Fawn Lake Dam, ID Number PA-00693.
Schuylkill River Basin, Plum Creek,
Schuylkill County, Pennsylvania.
Phase I Inspection Report.

PHASE I INSPECTION REPORT
NATIONAL DAM INSPECTION PROGRAM

PHASE I INSPECTION REPORT
NATIONAL DAM INSPECTION PROGRAM
FAWN LAKE DAM
NATIONAL ID #PA 00693
DER ID #54-175

SEEPAGE LOCATION PLAN
FAWN LAKE DAM
SHEET 5a OF 11

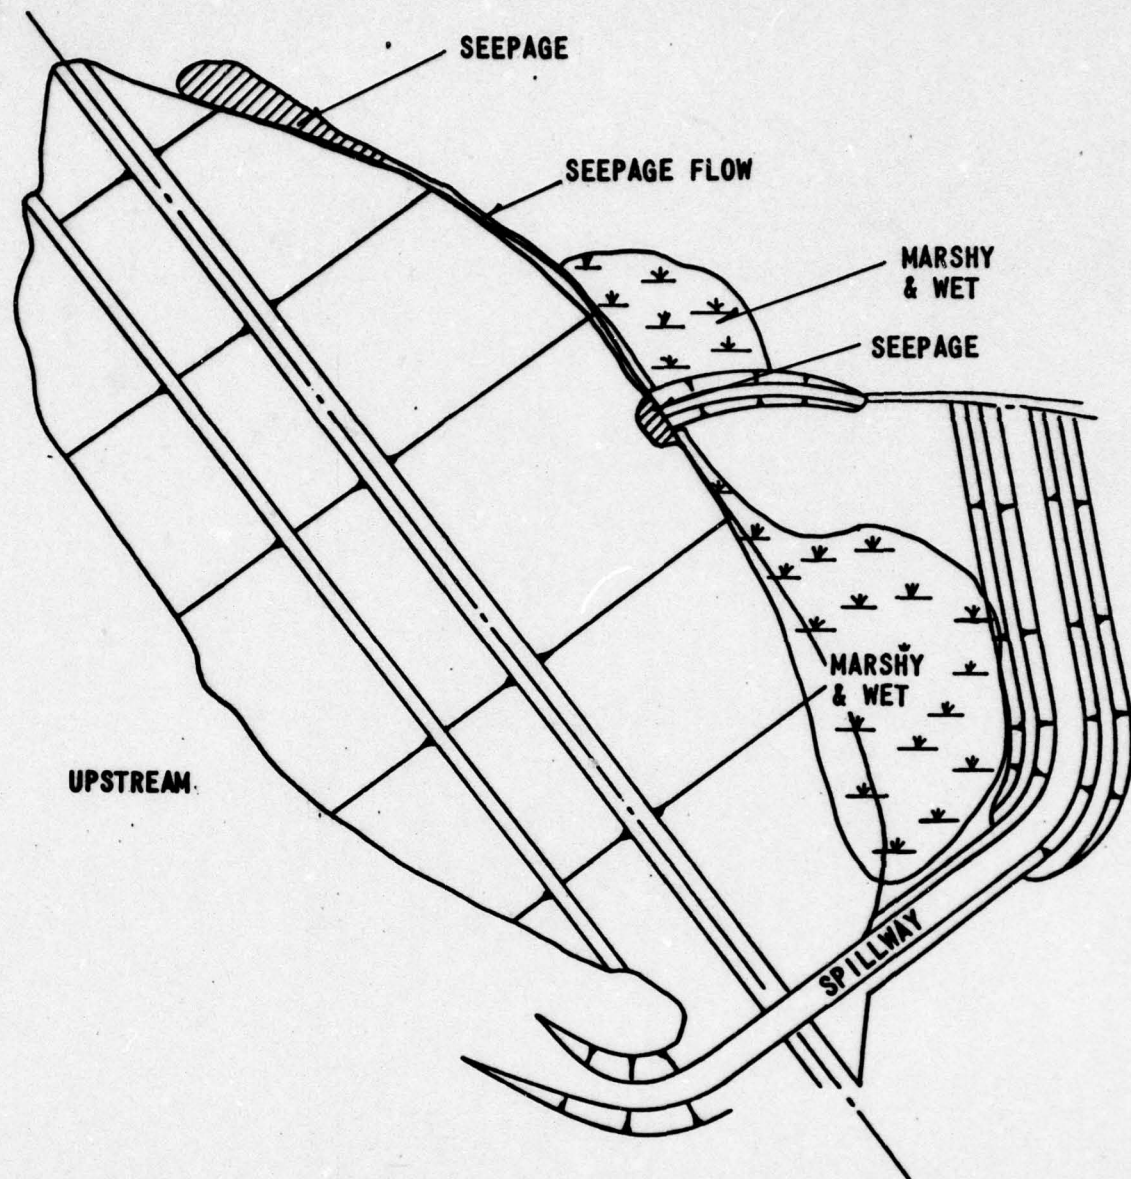
See sheet 5a. Clear seepage was observed along the downstream embankment contact with natural ground. Concentrated areas of seepage were observed on the left abutment initiating slightly below the apparent normal pool and around the pond drain pipe outlet structure. The areas of concentrated seepage on the left abutment is not covered with graded filter stone. Black willow trees mark the edge of the seepage zone to the right of the discharge structure. The area immediately downstream of the embankment toe was gradually wet and marshy with areas of standing water noted. The seepage rate, erosion and turbidity should be monitored.
